Re: Reevaluation of Louisville and Southern Indiana Ohio River Bridges Project  
Floodplain Considerations

## Louisville-Southern Indiana Ohio River Bridges Floodplains Reevaluation

Supplemental Final Environmental Impact Statement (FHWA-KY-SEIS-12-01-F) approved  
April 20, 2012

This reevaluation was prepared to document and correct inconsistent statements about floodplains that appear in the Supplemental Final Environmental Impact Statement (SFEIS) and Revised Record of Decision (RROD) for the Louisville-Southern Indiana Ohio River Bridges Project. The reevaluation clarifies the Project commitment to bridge floodplains, where feasible, consistent with the recommendations of the US Environmental Protection Agency (EPA).

## **Bridging the 100-year floodplain of Harrods Creek**

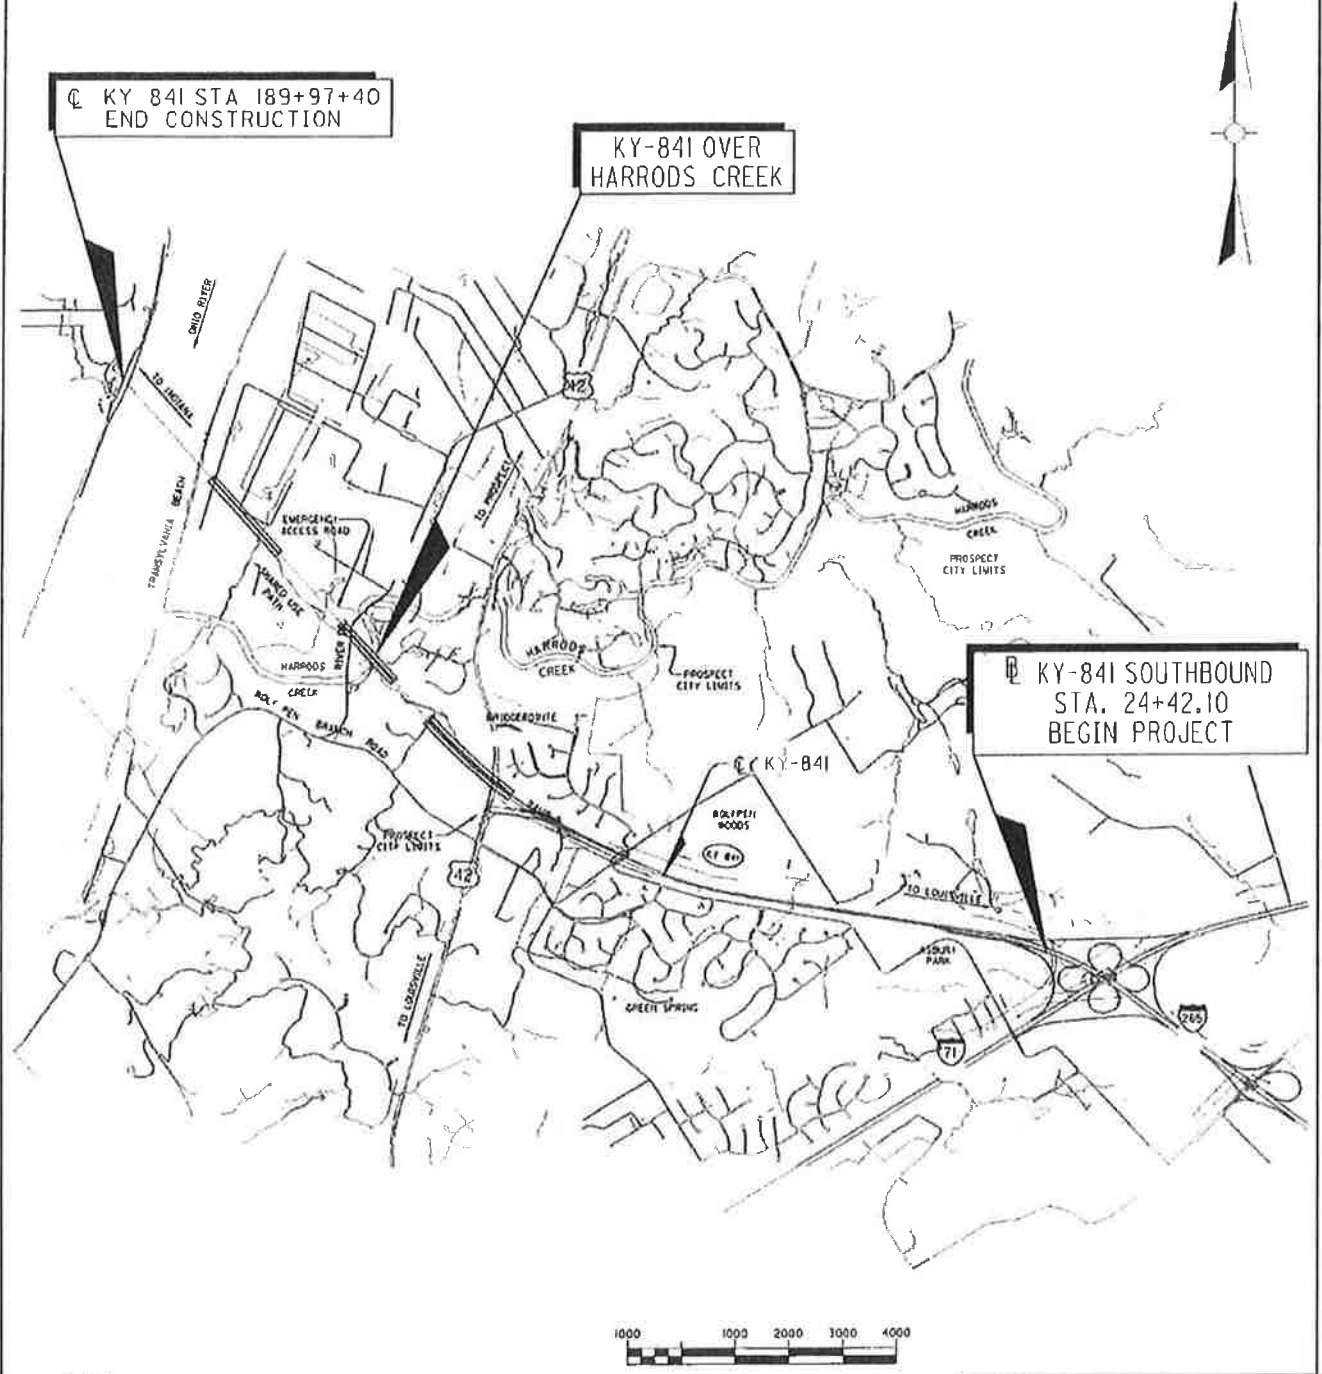
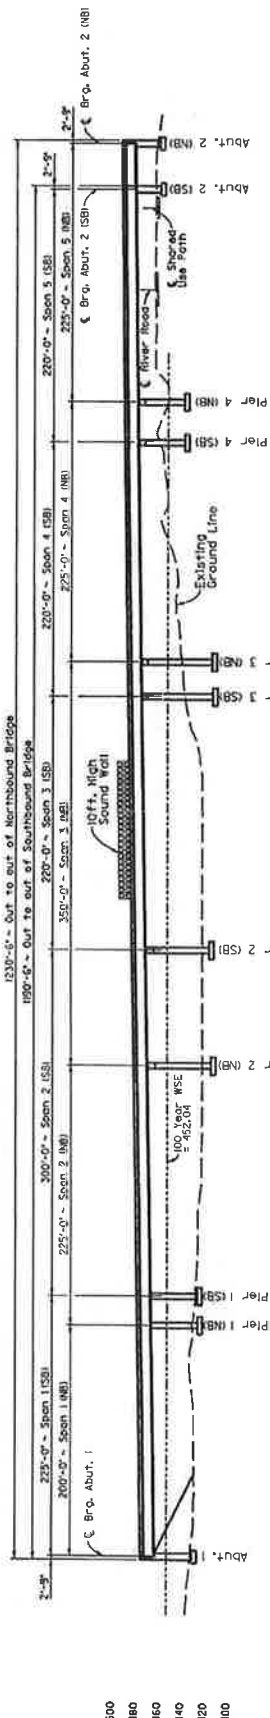
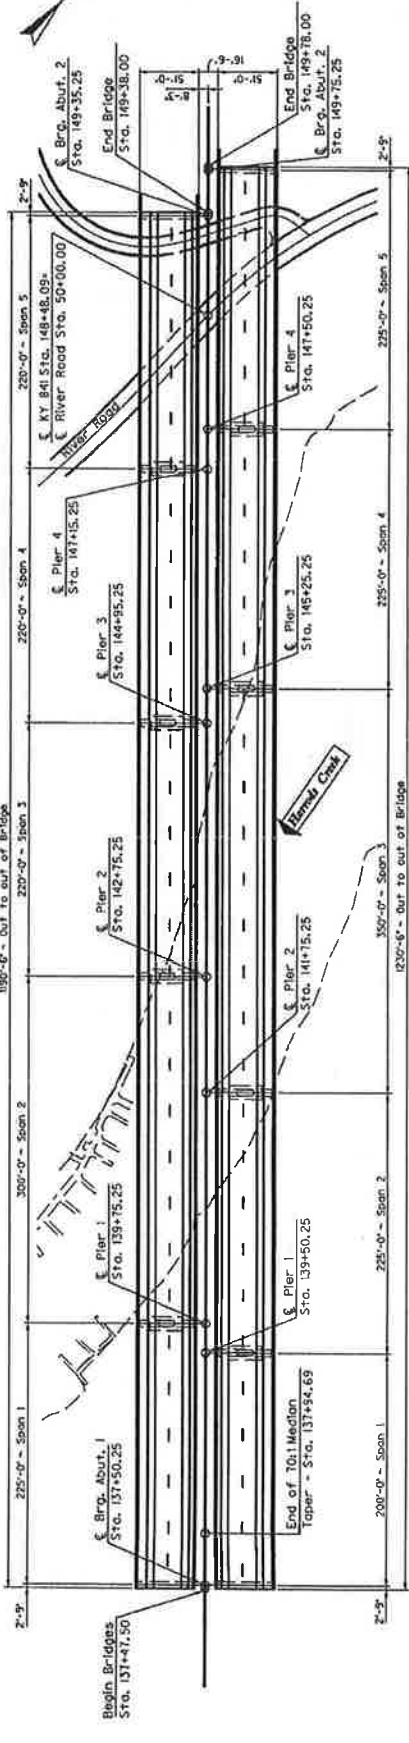
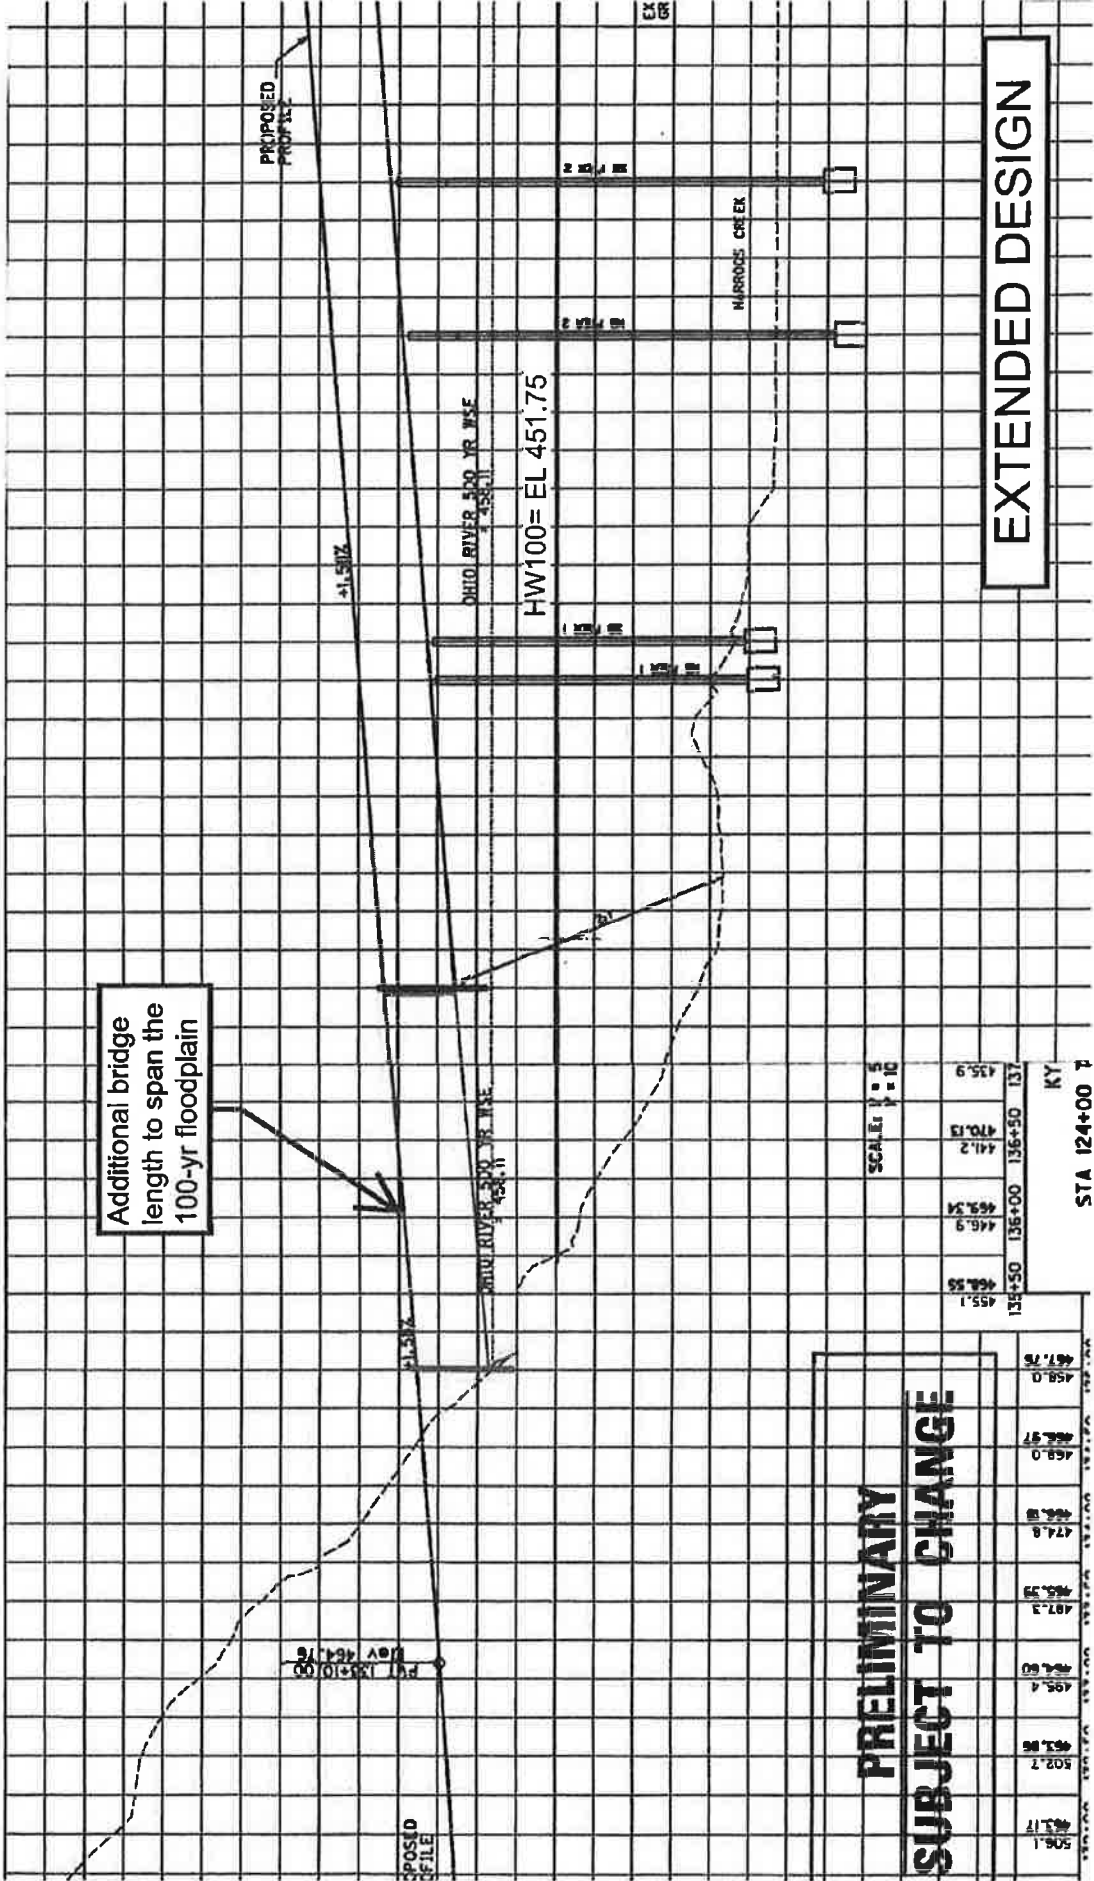
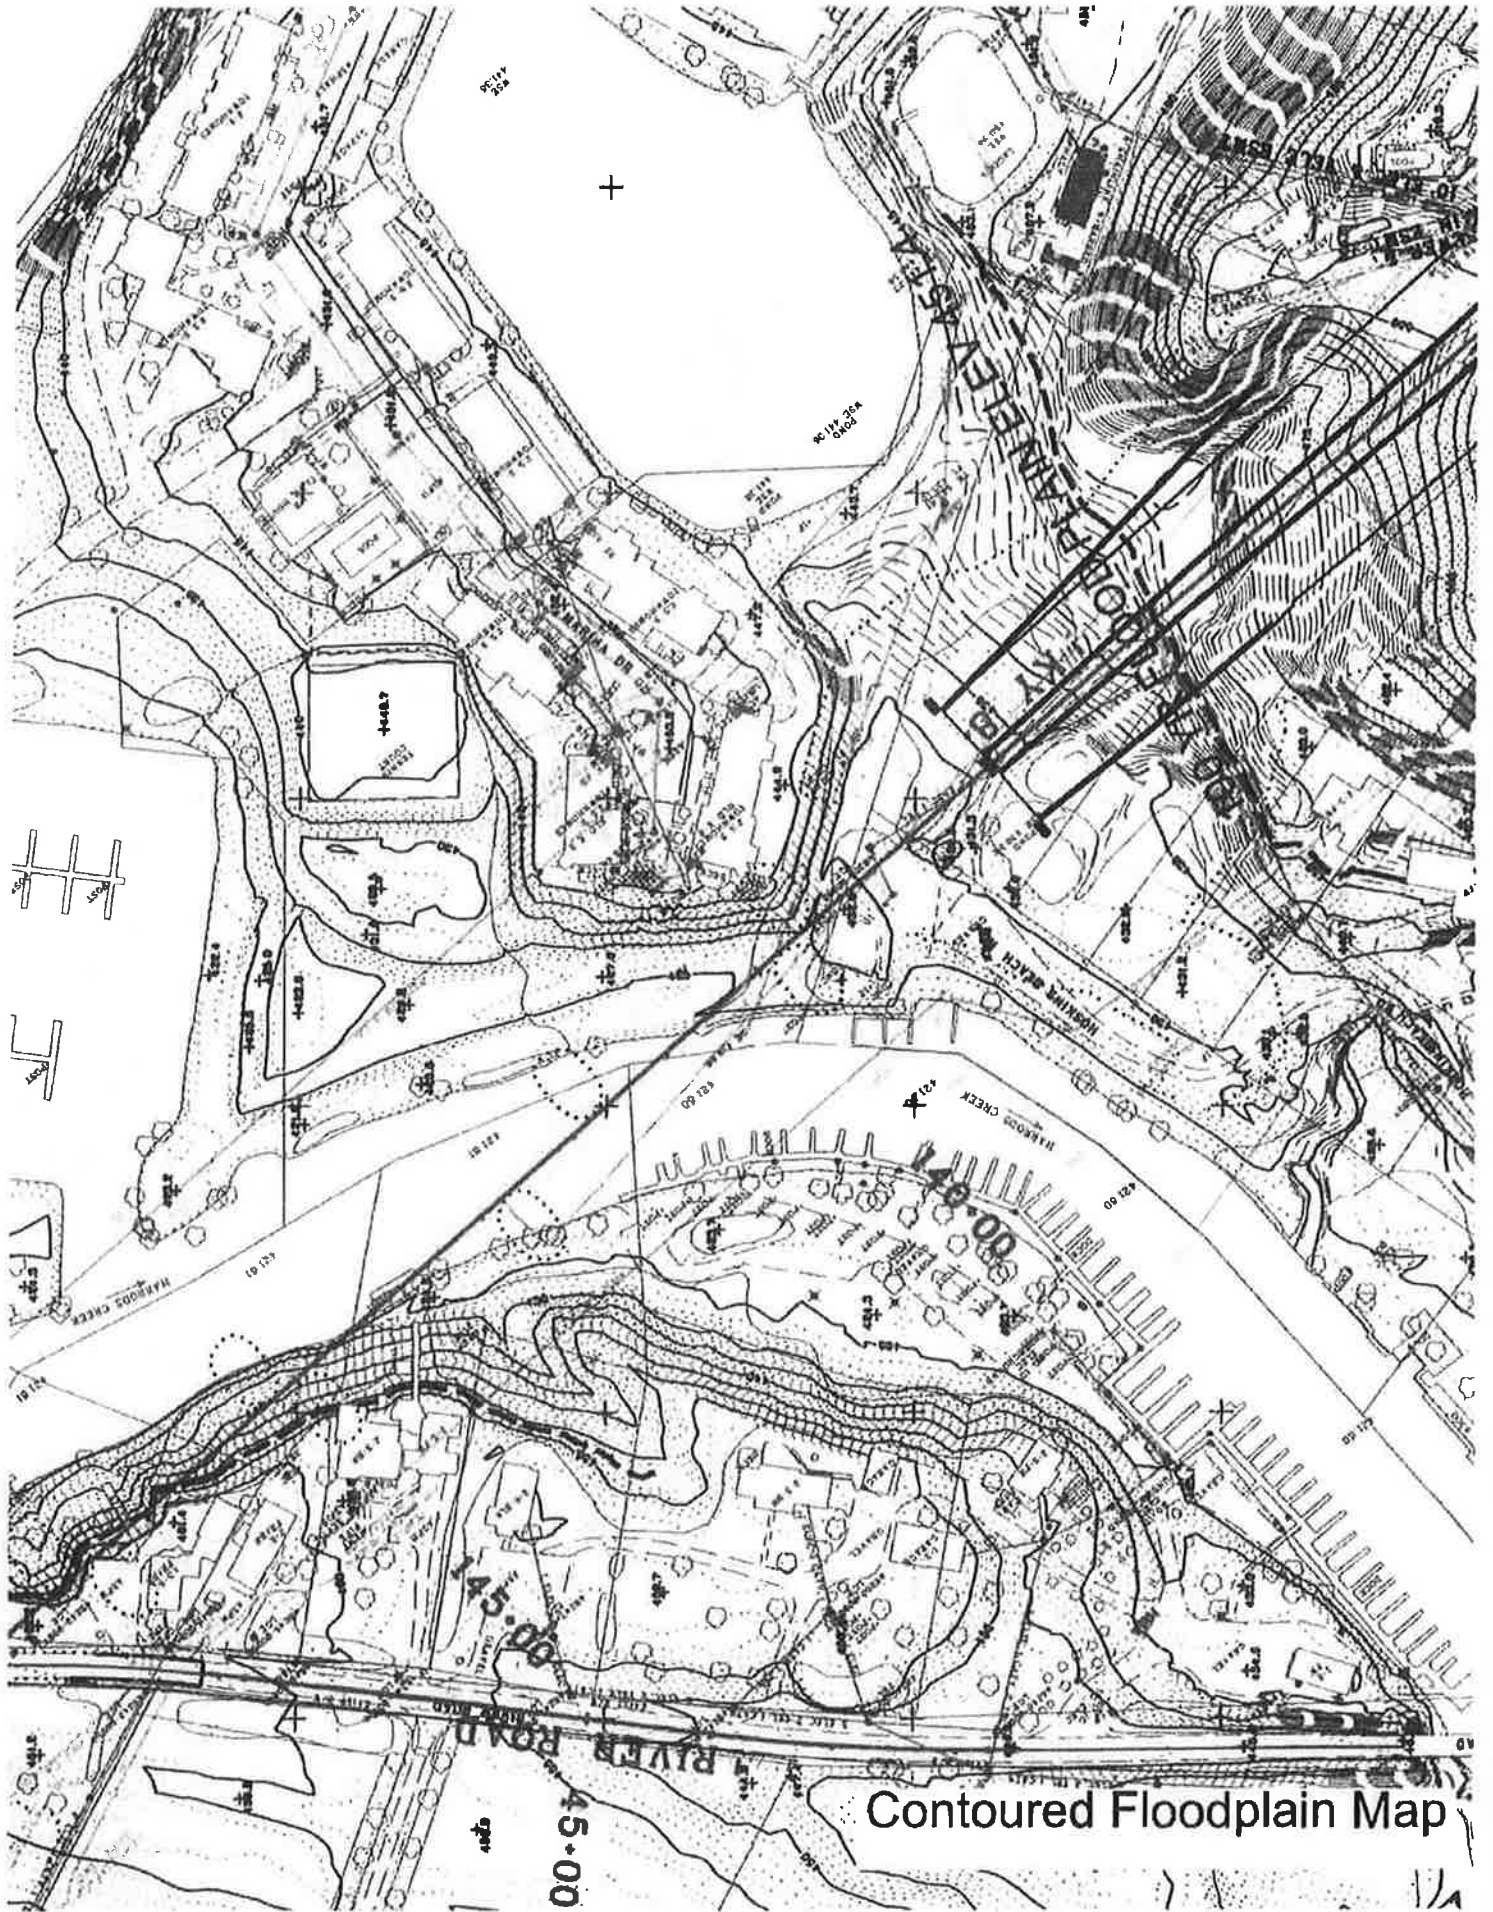
The proposed bridge will encroach into the 100-year floodplain only at the south end with a spill-through earth abutment with 2:1 slopes. The spill-through abutment will have a footprint area of 1.8 acres and project into the floodplain 250 feet. It will have a cross sectional area of approximately 1800 square feet which is 9.8% of the total cross sectional area of the 100-year floodplain. At the 100-year flood, the proposed bridges will produce a backwater effect of 0.02'

A bridge constructed to completely span the 100-year floodplain would need to be 250' longer. Built to the same specifications of the current proposed design, the additional construction cost would be \$6,546,870.

Additional bridge length to span the 100-yr floodplain
